# Document G701® – 2017

## Change Order

**PROJECT:** *(Name and address)*  
HCHS CTE Renovation  
2424 Zion Road  
Henderson, KY 42420

**CHANGE ORDER INFORMATION:**  
Change Order Number: 01  
Date: October 15, 2024

(Sketch)

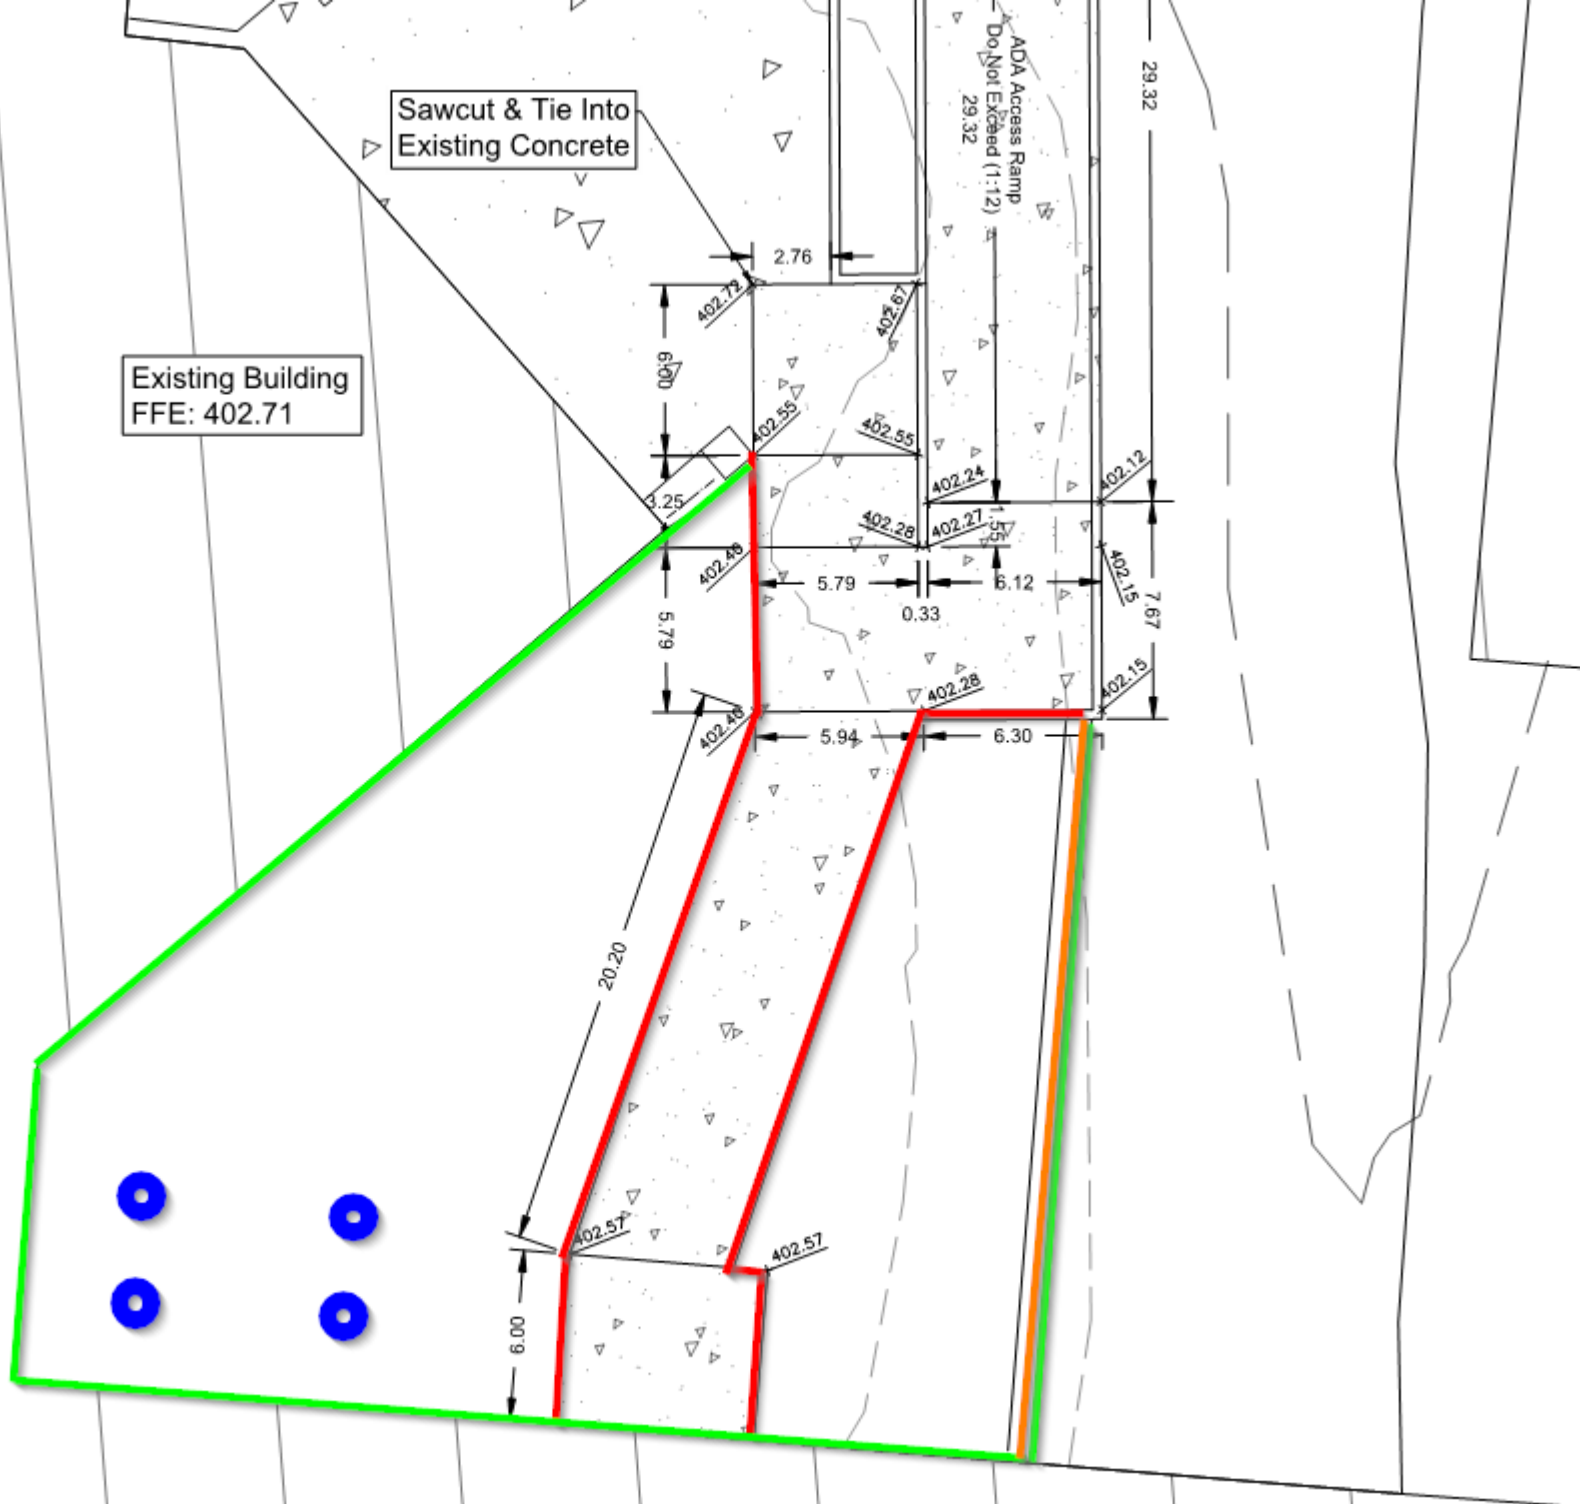
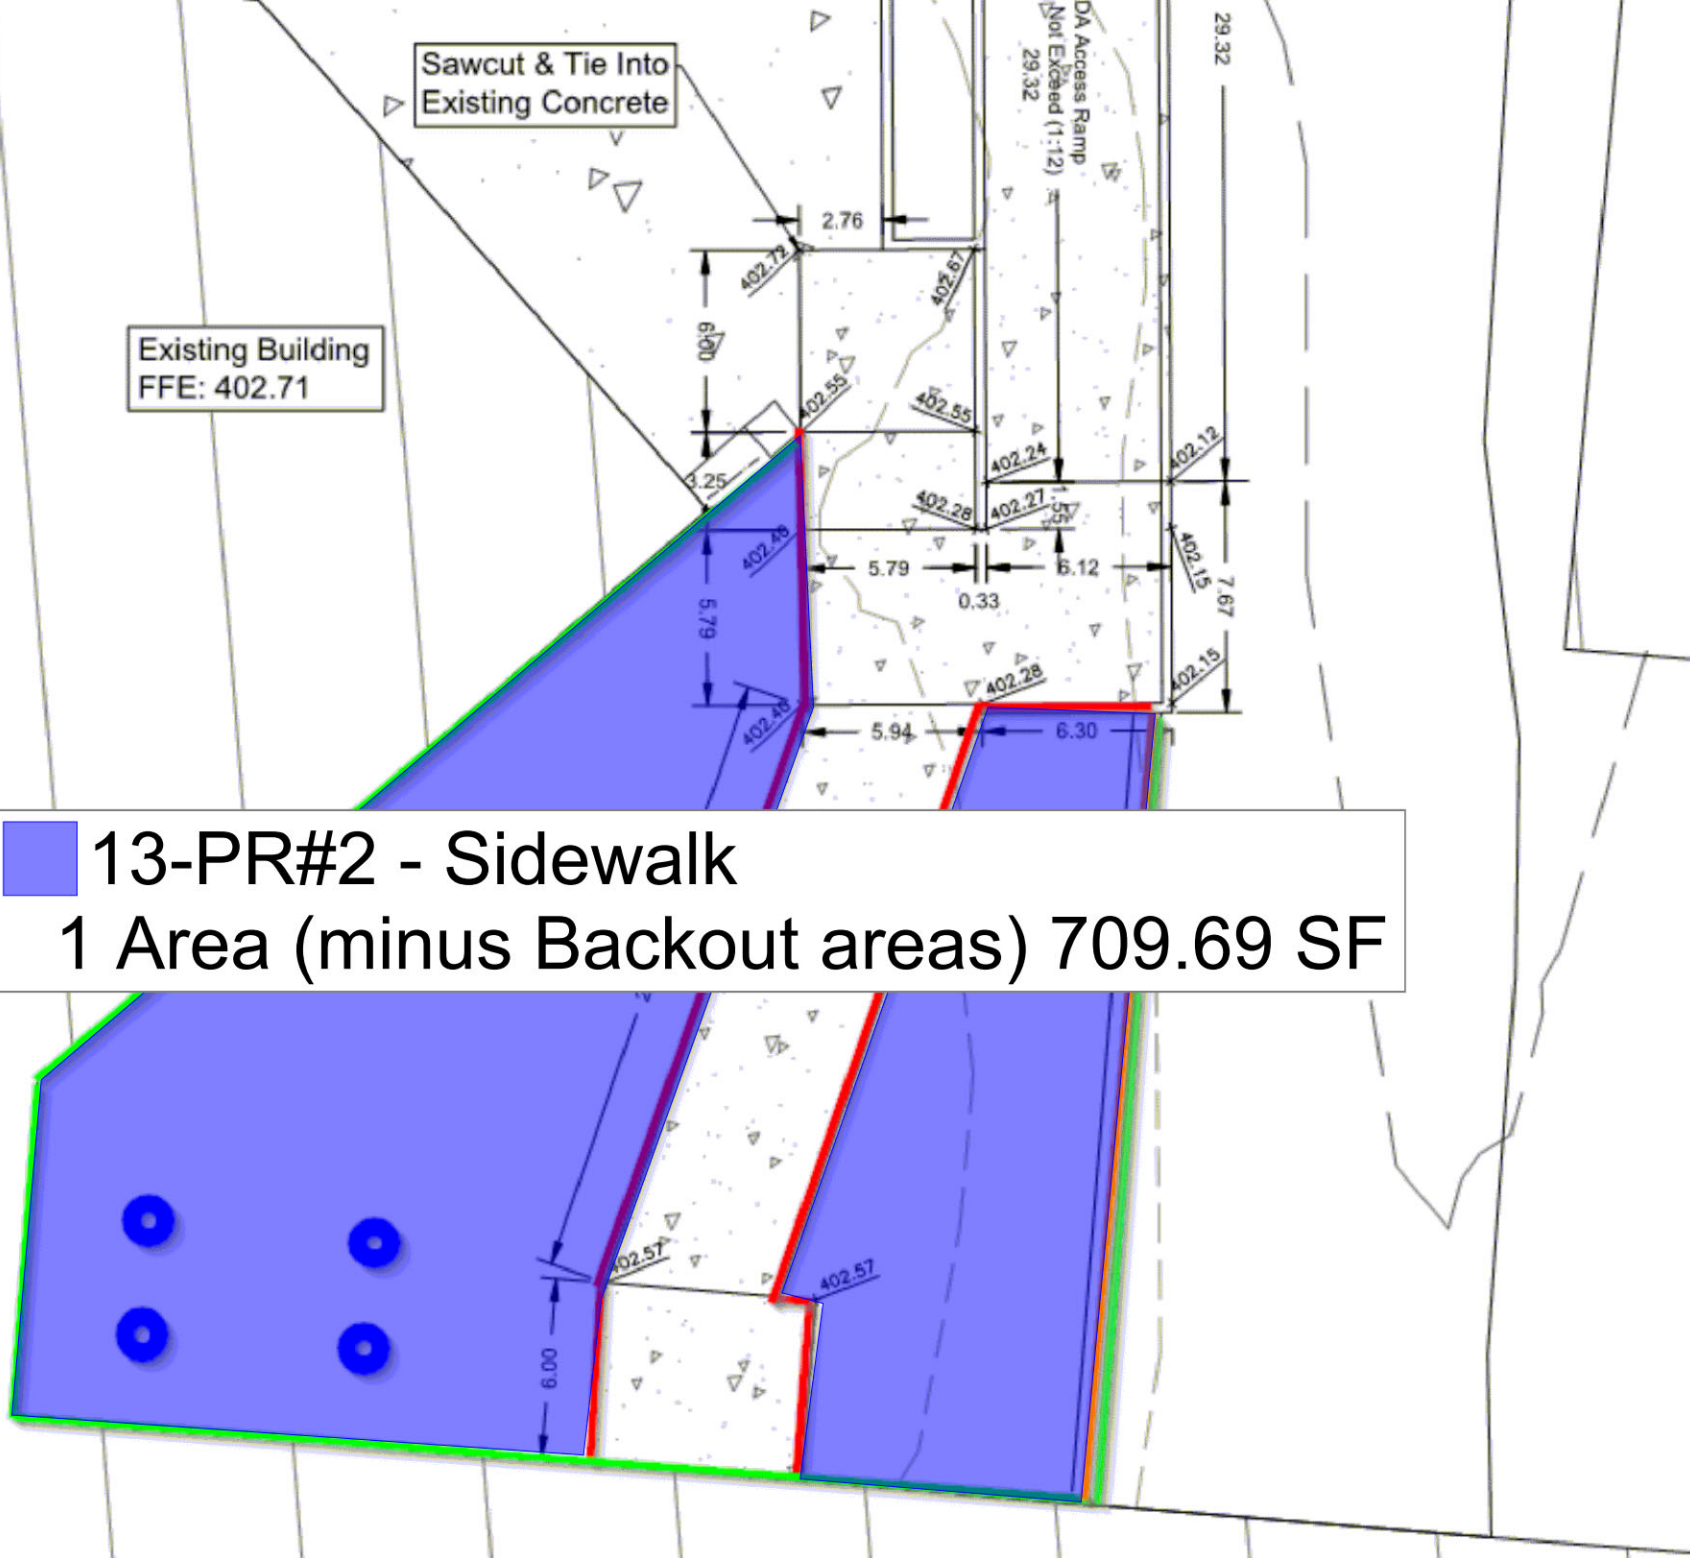
Please provide a quote for the infill of the gravel area adjacent to the entry ramp as noted in the attached sketch:

- Green – area of concrete infill
- Red – Removal of handrails from scope
- Blue – demolish existing bollards
- Orange – new location of guard rail at edge of existing retaining wall.

Please see the pricing below to add additional sidewalk per PR#2 drawing, as well as, additional sidewalk at the door:

Bowling (Site Demolition) - \$4,700.00  
ARC (Concrete and Stone Base Work) – \$9,744.00  
Matthews Creek (Handrail) - <\$5,661.00>  
Overhead – \$878.00  
Total Add - \$9,661.00
